Access Compliance Report

Public Rights-of-Way

(Pedestrian Signals)

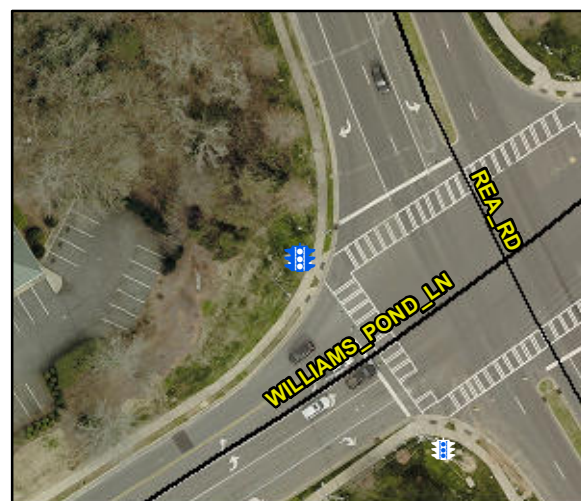
Yes	B 1 Clear Xing Direction?	ClearlyMarked	Yes	B 2 Clear Xing Direction?	ClearlyMarked
	B 1 Crossing Direction	To SE		B 2 Crossing Direction	To NE
Yes	B 1 DistanceTo XWalk (in)	0.0	No	B 2 DistanceTo XWalk (in)	76.0
No	B 1 DistanceTo Curb (in)	128.0	No	B 2 DistanceTo Curb (in)	128.0
Yes	B 1 Diameter (in)	2.0	Yes	B 2 Diameter (in)	2.0

Possible Solutions: Replace Signal Push Button With APS Button on New Post. Remove & Relocate Sign.
